Subject: Response to Deficiency of License Applications and Request for Additional Information  
Hayward Hydroelectric Project (FERC Project No. 2417-067)  
Trego Hydroelectric Project (FERC Project No. 2711-025)

On May 14, 2024, the Federal Energy Regulatory Commission (FERC or Commission) issued a *Deficiency of License Applications and Request for Additional Information* letter to Northern States Power Company - Wisconsin (NSPW) regarding its final license applications for the Hayward Hydroelectric Project (FERC No. 2417) and the Trego Hydroelectric Project (FERC No. 2711). Accordingly, NSPW hereby submits the following information and responses as requested in the Commission's aforementioned letter.

Figure 1 Town of Trego Park Boat Landing

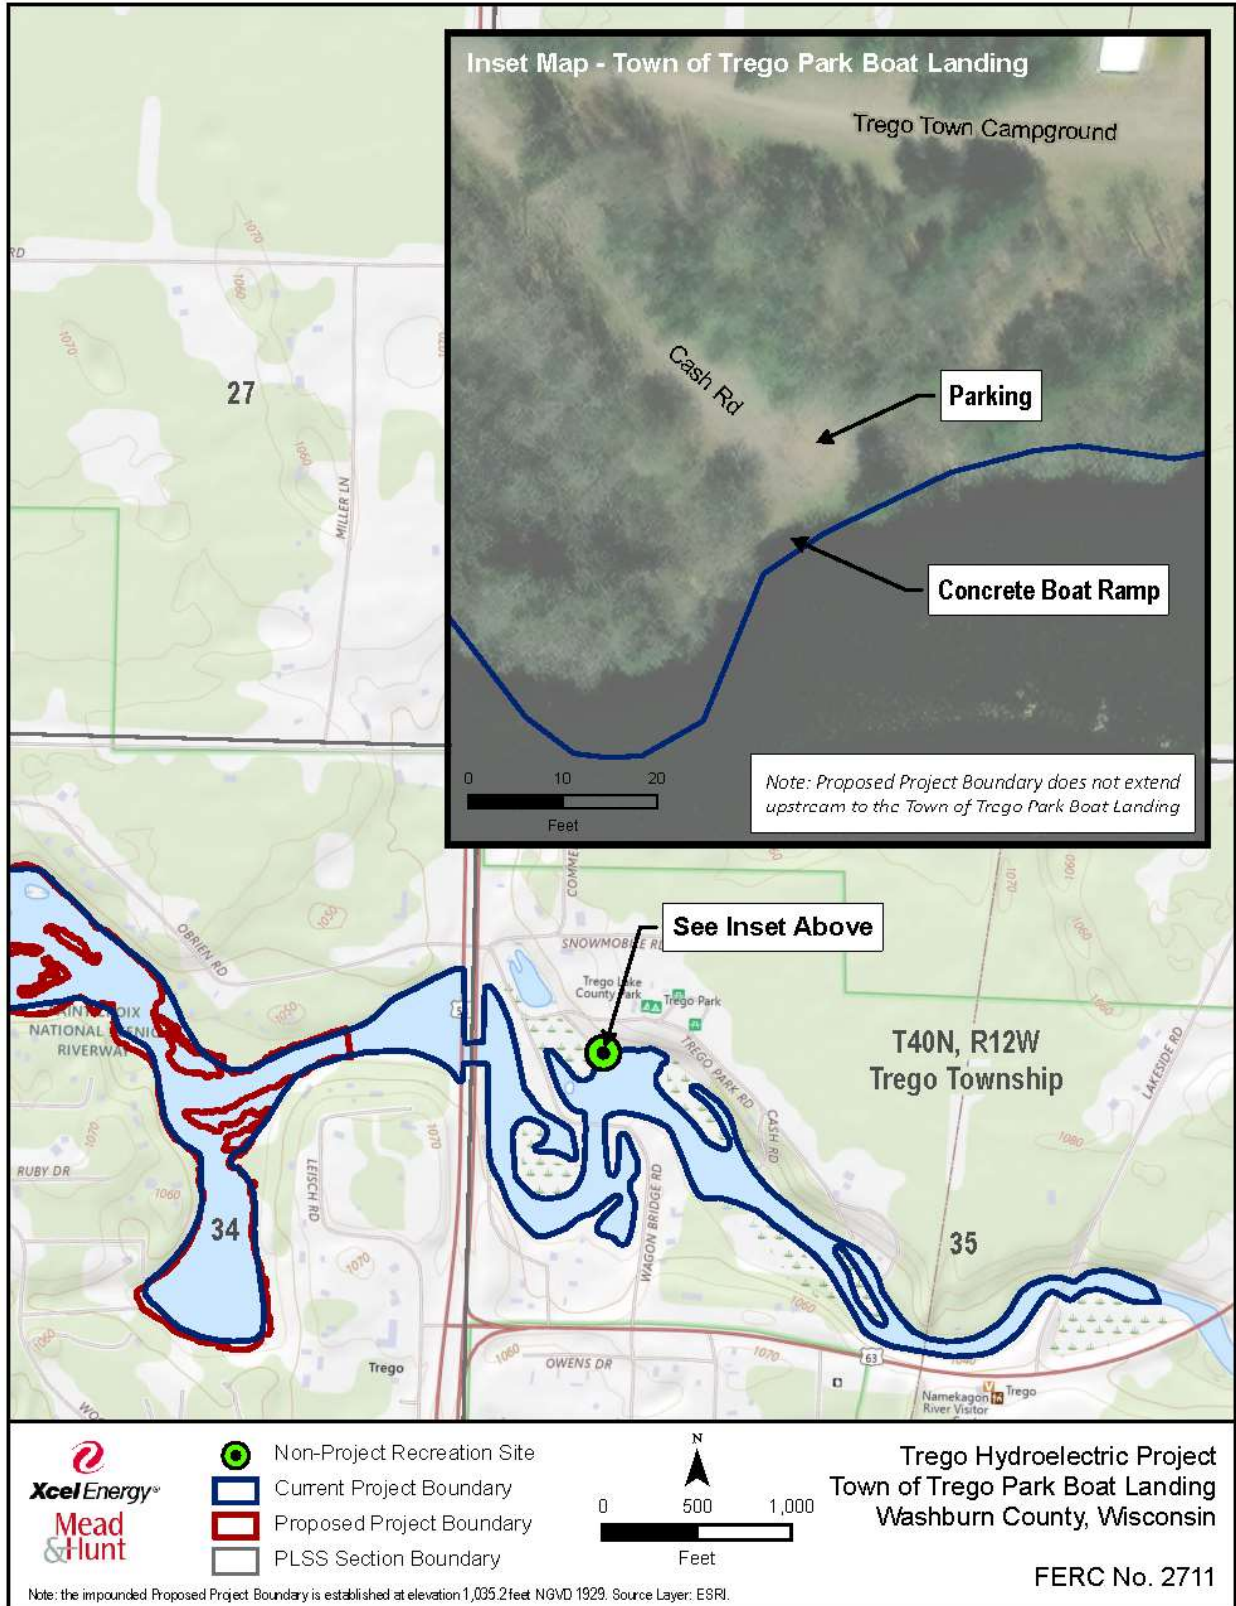
**AIR Comment 21:**

**Figure 1** shows the Town of Trego Park Boat Landing in relation to the current and proposed boundaries. The entire recreation site is located outside of the proposed Project boundary. The portion of the site’s concrete boat ramp extending into the water is assumed to be located within the current boundary.<sup>3</sup> The parking area is outside of the current boundary.
